**CITY OF TROUTDALE
CONSTRUCTION DETAILS
INTERIM CHANGES**

TO: File
FROM: Jim Galloway, Public Works Director
DATE: July 23, 1999
RE: Construction Standards for Public Works Facilities May 1997:
Interim Change #1

TO: FILE
FROM: JIM GALLOWAY, PUBLIC WORKS DIRECTOR
DATE: SEPTEMBER 13, 1999
**RE: CONSTRUCTION STANDARDS FOR PUBLIC WORKS FACILITIES,
MAY 1997: INTERIM CHANGE NO. 2**

Figure 10. Driveway dimensions measurements (see Table 2).

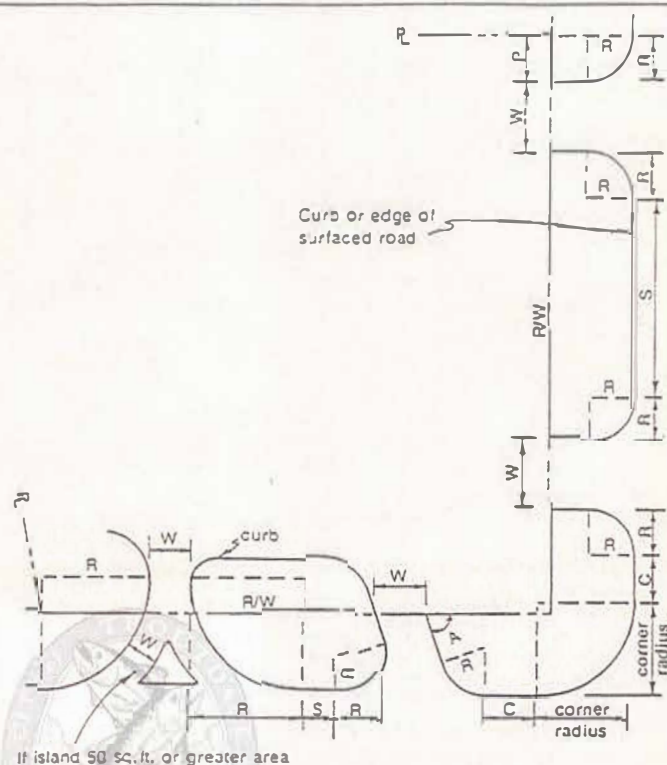
- e. A driveway shall not be closer than twenty (20) feet to a point of curvature or point of tangency of a curb return. (Dimensions "C" and "R", Figure 10, Page 19, "Guidelines for Driveway Location & Design", Institute for Transportation Engineers, 1987.

DRAWING NO.
II - 1.1

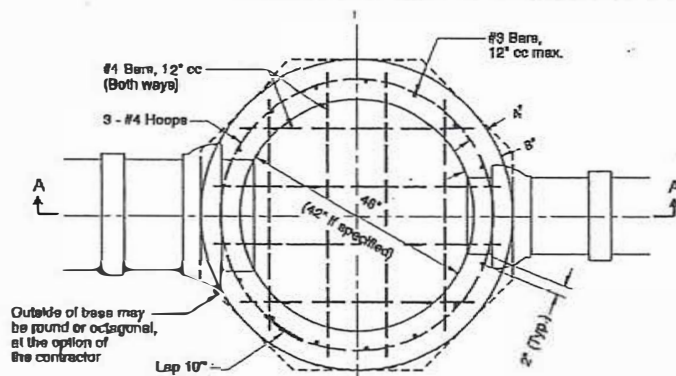
Drawing No. II-1 (Commercial/Industrial Street Cross Section) Updated 1997 is replaced with the attached Drawing No. II-1.1 (Commercial/Industrial Street Cross Section) Updated 2007.

CAST IN PLACE MANHOLE BASE

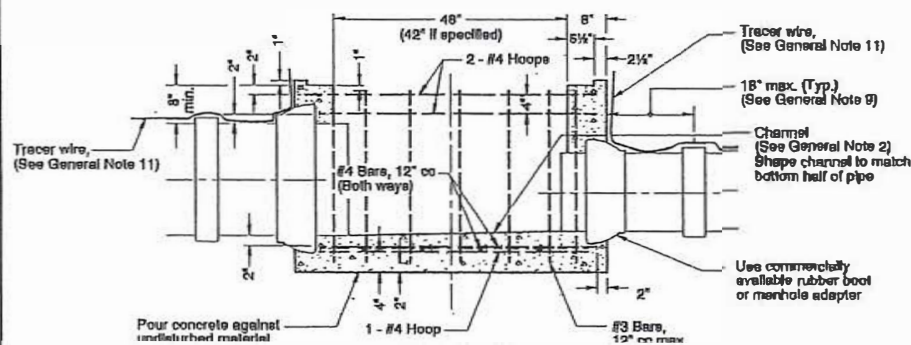
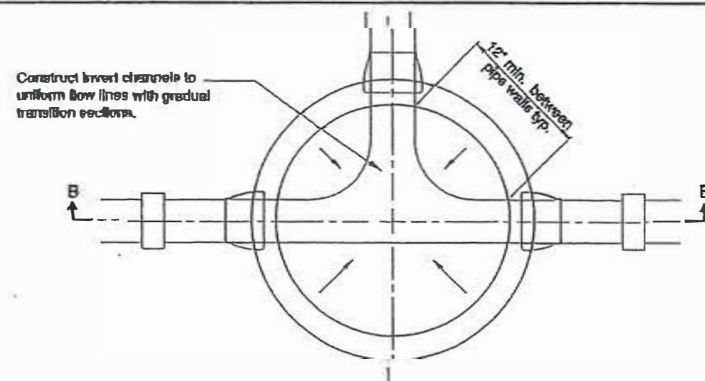
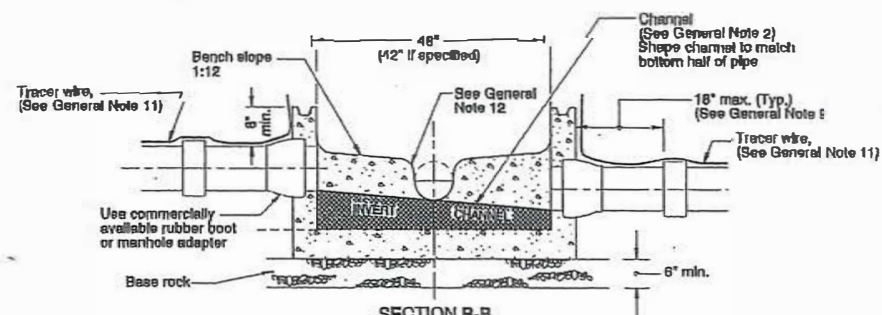
Drawing No. VIII-3 (48" Manhole Base (Sanitary or Storm)) Updated 1997 is replaced with ODOT/APWA standard drawing RD-344 (Standard Manhole Base Section), attached.

Drawing #:	File Name:
RD254-CoTA	RD254 COT A.dwg
Date:	Drawn by:
5/17/2012	TH

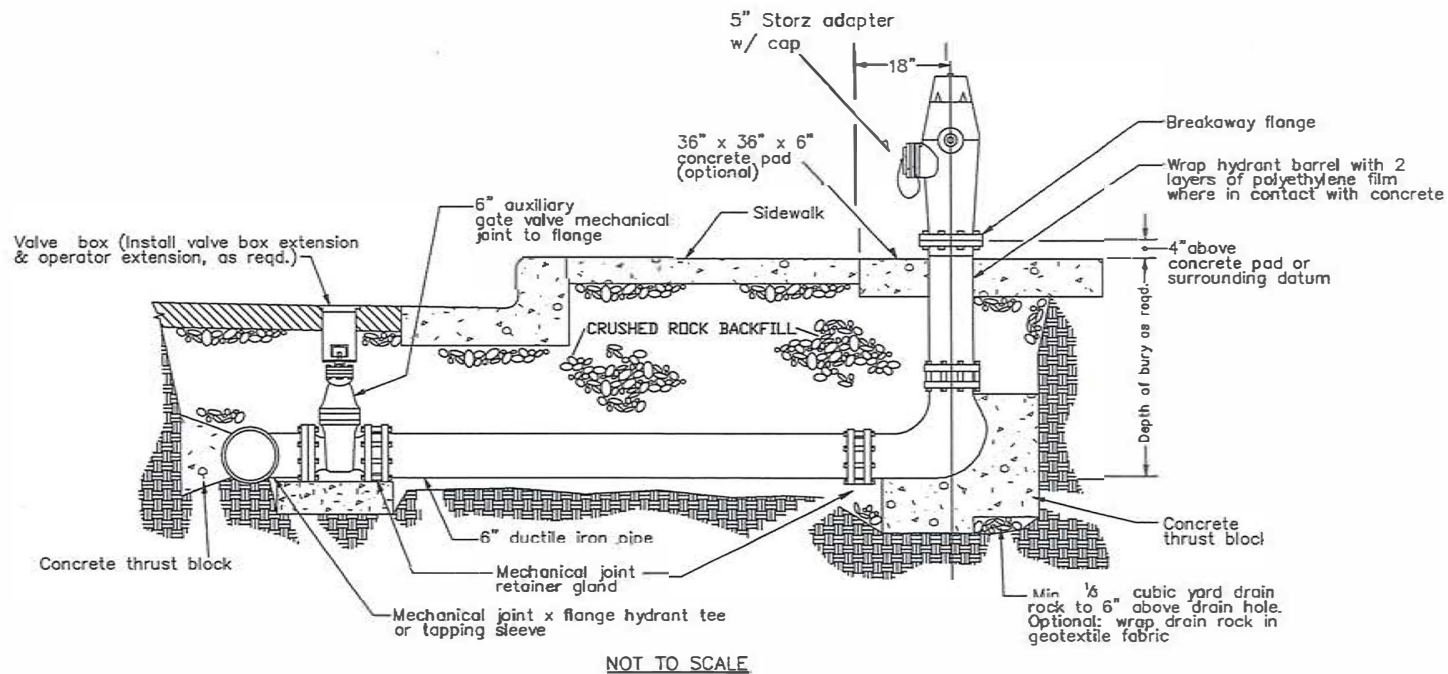
1. Replace Standard Drawing IV-2, "Fire Hydrant Assembly (Behind Sidewalk), with the attached drawing RD 254-CoTA, "Hydrant Assembly (Behind Sidewalk)" [Attached]
2. Replace Standard Drawing IV-3, "Fire Hydrant Assembly (Behind Curb), with the attached drawing RD 254-CoTA, "Hydrant Assembly (In Landscaping Strip)" [Attached]

OREGON STANDARD DRAWINGS
SEPARATED SIDEWALK DRIVEWAYS
OR ALLEYS (OPTIONS H, I & J)
LOCAL JURISDICTIONS

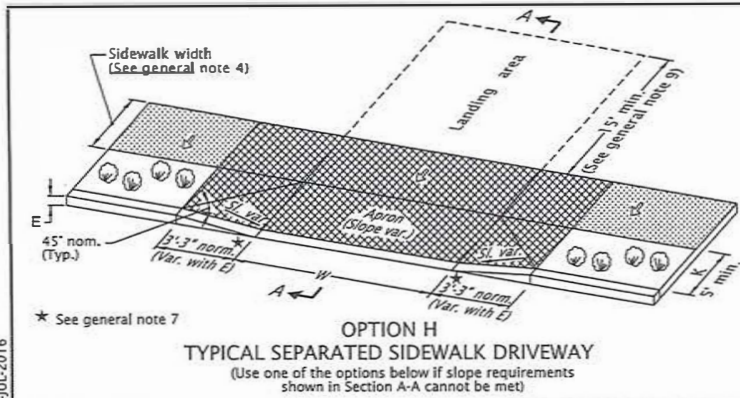
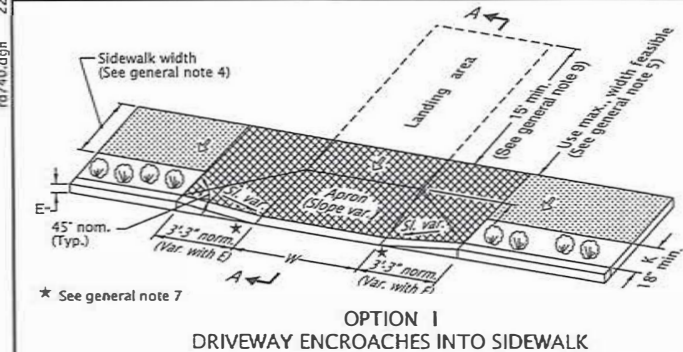
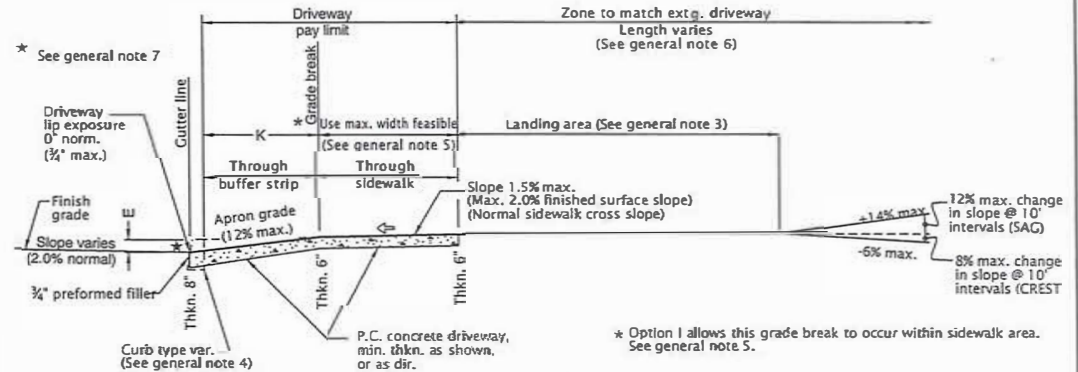
1. Replace ODOT Drawing RD 740, "Separated Sidewalk Driveways or Alleys (Options H, I, & J) Local Jurisdictions with the attached drawing RD 740 (bearing the same title).
2. Replace ODOT Drawing RD 745 and RD 750, "Curb Line Sidewalk Driveways or Alleys (Options K & L) Local Jurisdictions and "Curb Line Sidewalk Driveways or Alleys (Options M & N) Local Jurisdictions with the attached drawings RD 745 and RD 750 (bearing the same title).
3. The following driveway width standards shall apply to all driveway access points onto all City of Troutdale controlled rights-of-way:

DRAWING NO.
II-25

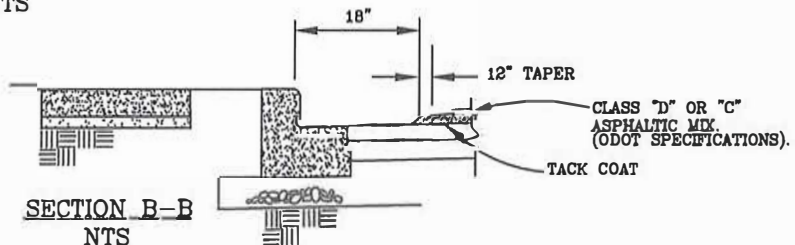
Replace Standard Drawing II-25 (14' Wide Speed Hump) with the revised Standard Drawing II-25 bearing the same title, attached.

RD755

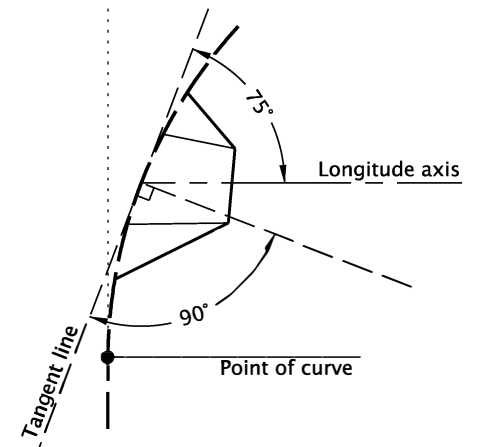
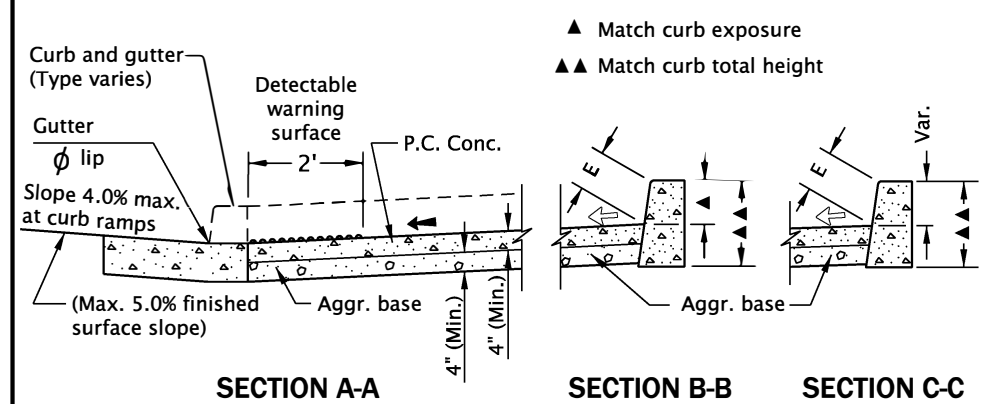
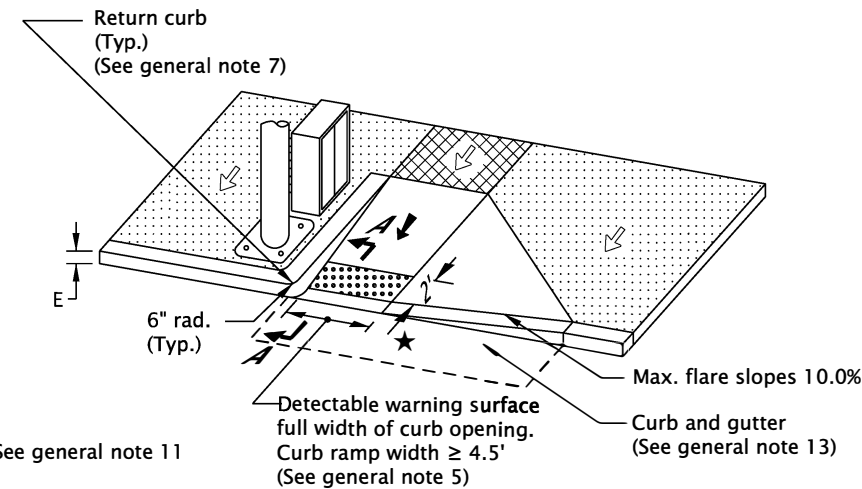
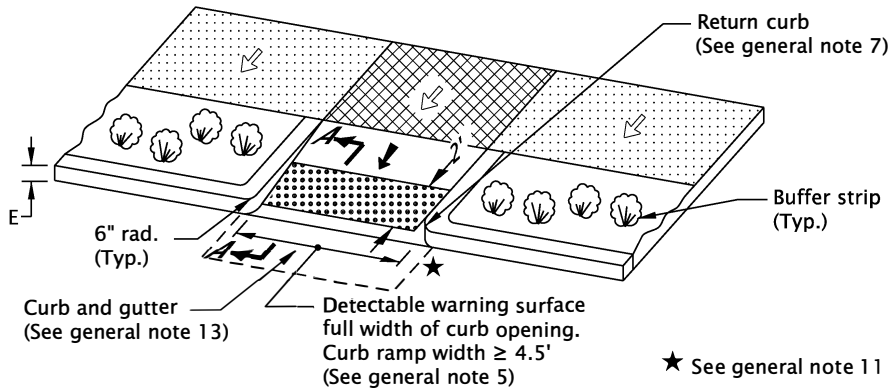
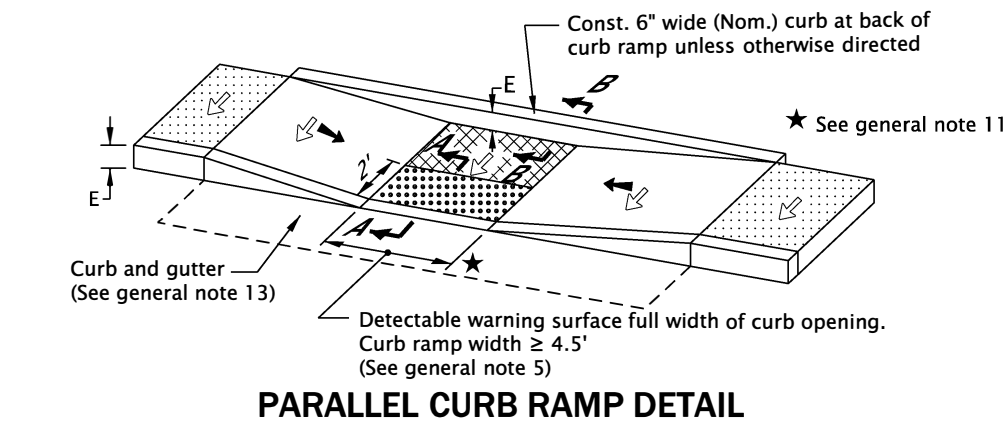
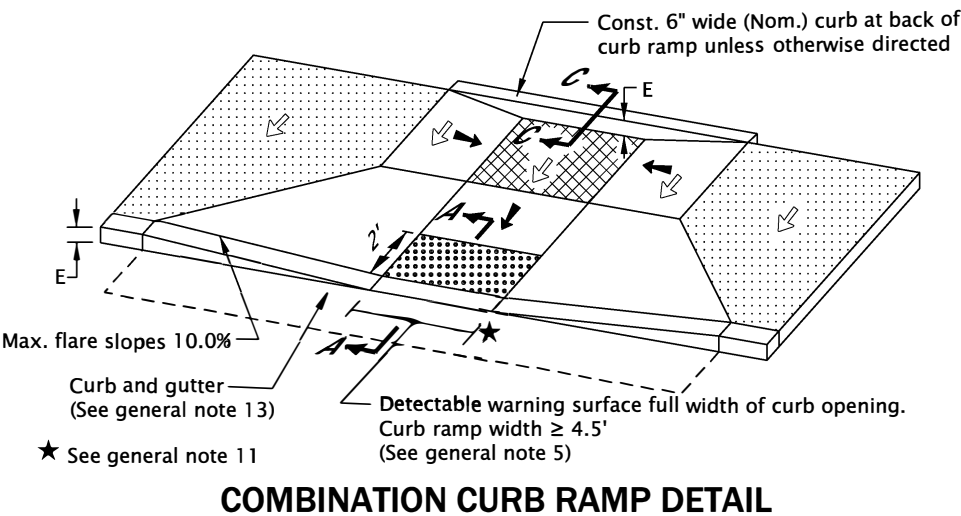
1. Sidewalk ramp drawings specified in Interim Change #24 (July 2014) are replaced as follows:
 - a. Replace ODOT Drawing RD 755, "Sidewalk Ramp Details" (July 2013) with ODOT Drawing RD 755, "Curb Ramp Details", revised January, 2019 (attached).

RD756

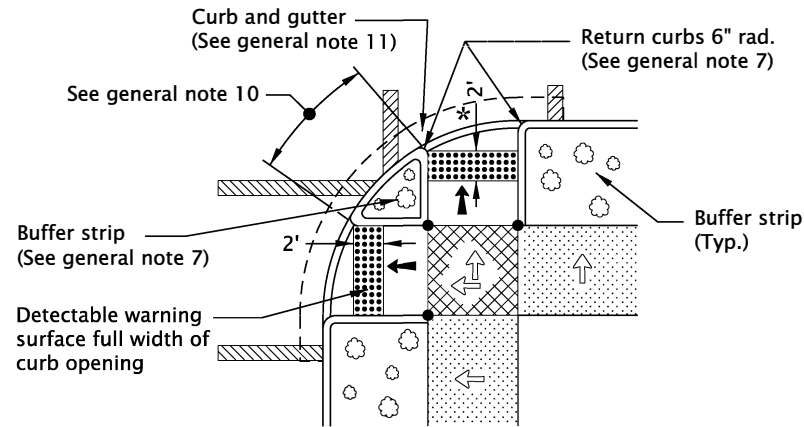
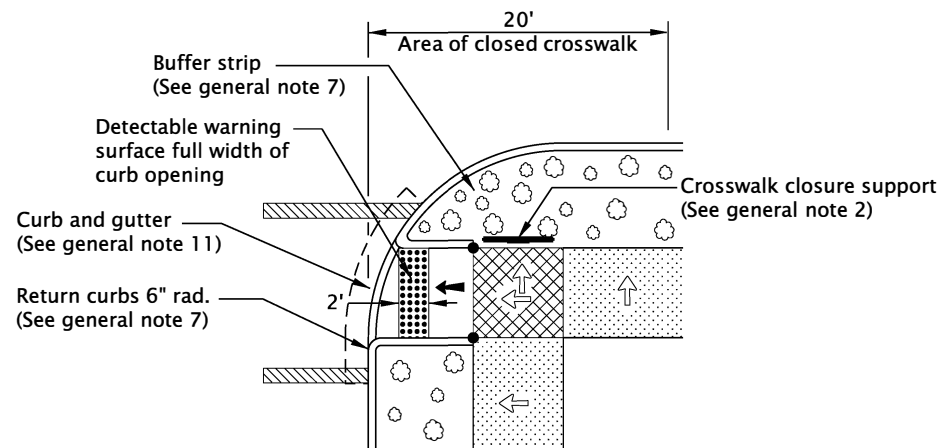
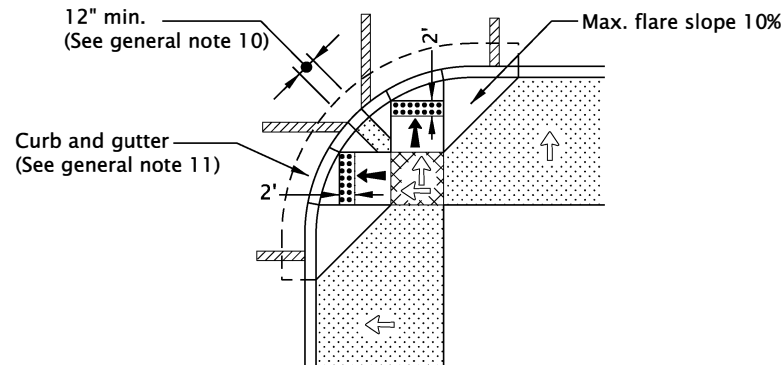
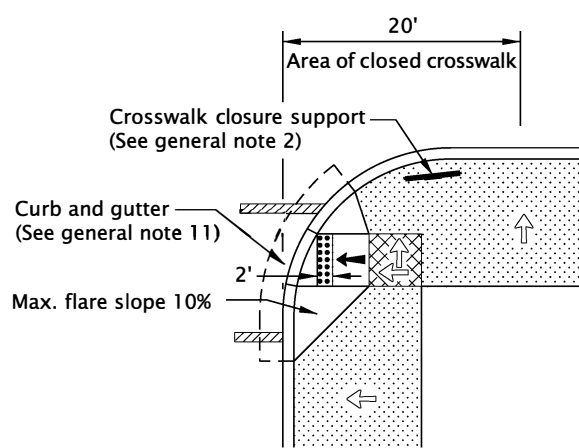
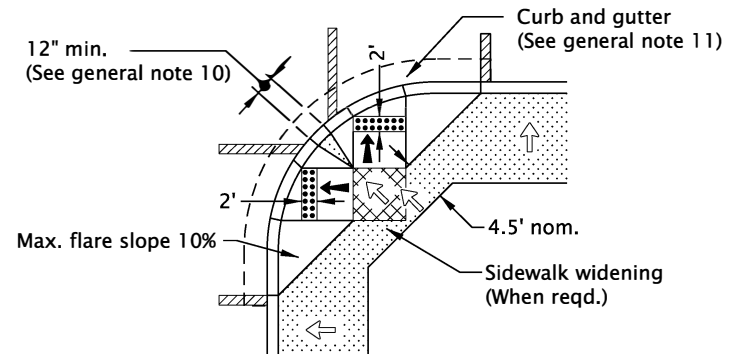
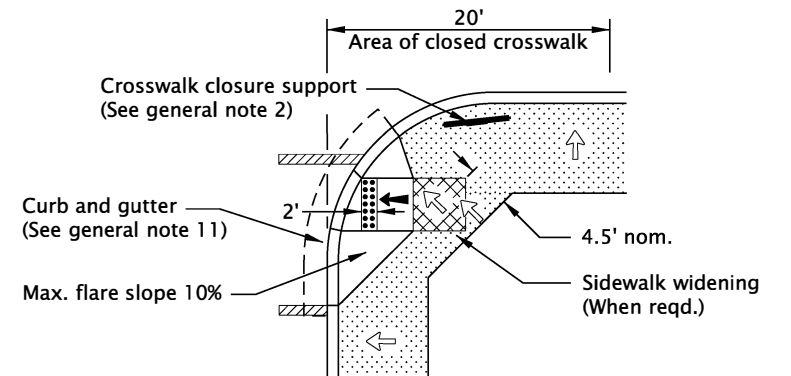
- b. Replace ODOT Drawing RD 756, "Sidewalk Ramp Placement Options, Curb Radii $\leq 15'$ " (July 2013) with ODOT Drawing RD 756, "Curb Ramp Layout Options Small Radii", revised January 2019 (attached).
